Decision Document

Licence Holder: **Exterra Resources Limited**

Licence: **L9012/2016/1**

Premises address: Second Fortune Gold Mine
Mining tenement M39/255, M39/649, M39/650 and miscellaneous licence
L39/12
MENZIES WA 6436

Figure 2: Map depicting the location of monitoring bores around Ponds 1 and 2.

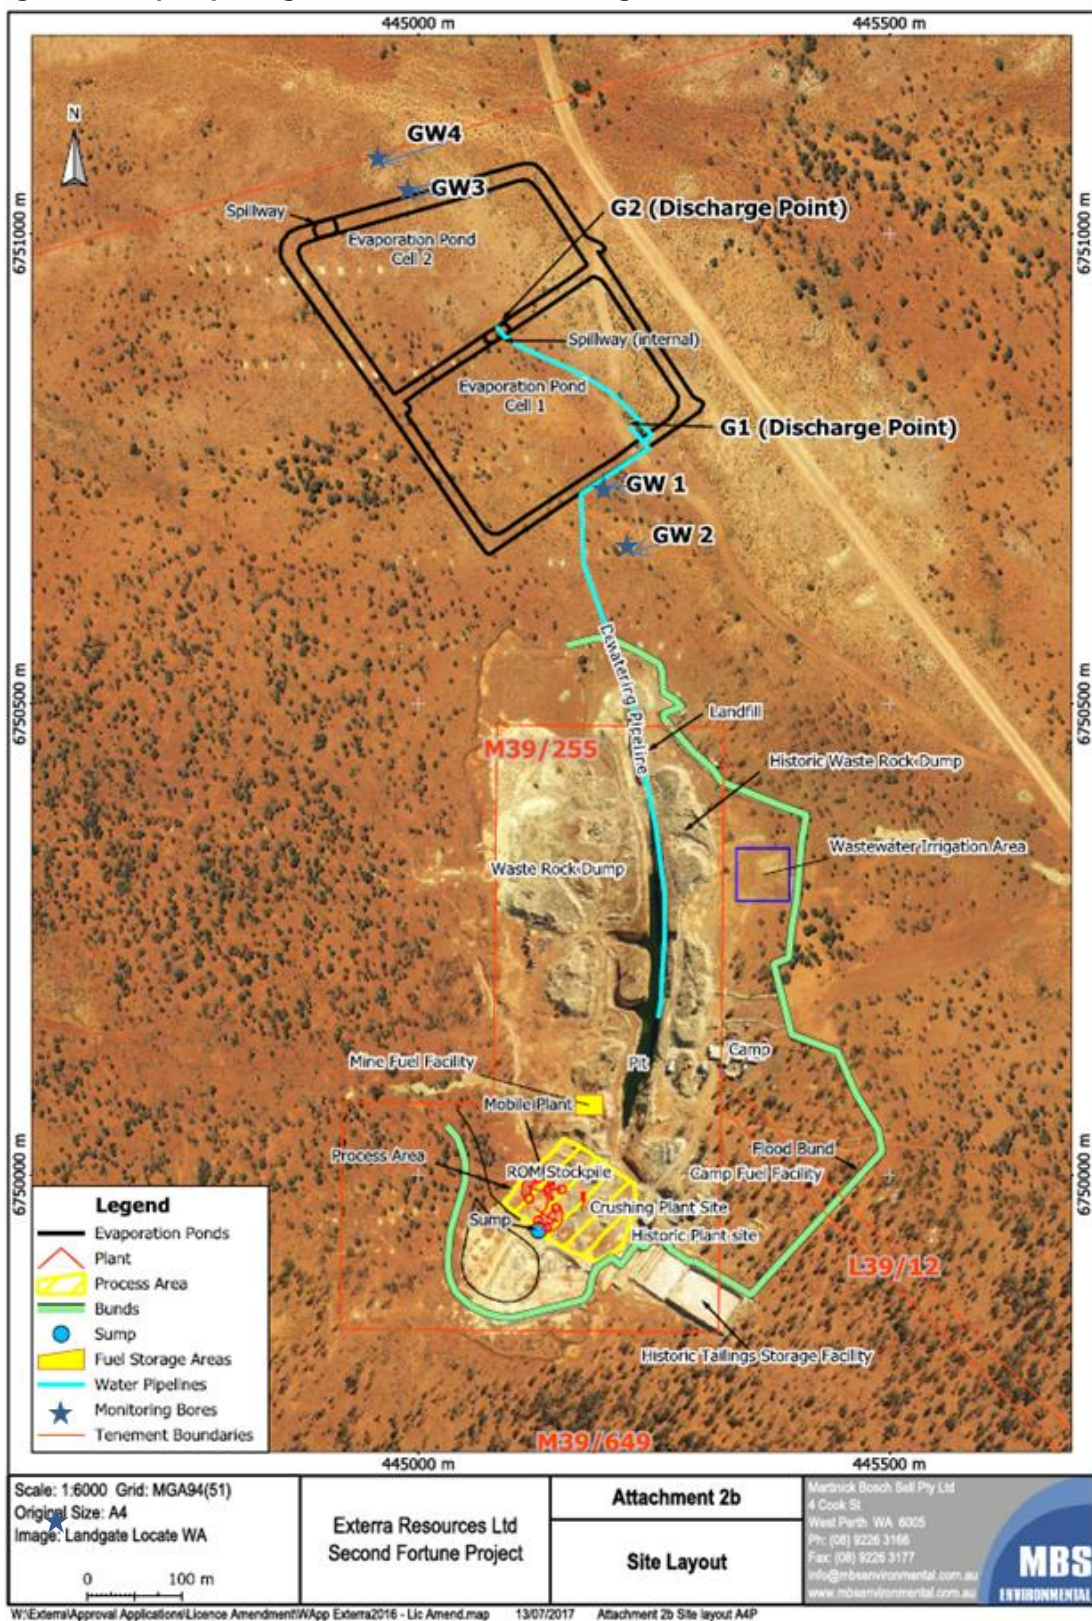
Condition 3.2.1 has been applied to the licence to monitor volumetric flow rate to the ponds. Groundwater monitoring at bores GW1, GW2, GW3 and GW4 have been applied to the licence

through condition 3.3.1 to enable the monitoring of potential impacts from seepage through base materials. Further parameters have been included such as cobalt (Co), cadmium, mercury (Hg) and thallium (Tl). These elements are mobile or somewhat mobile in neutral conditions (Smith, 2007).
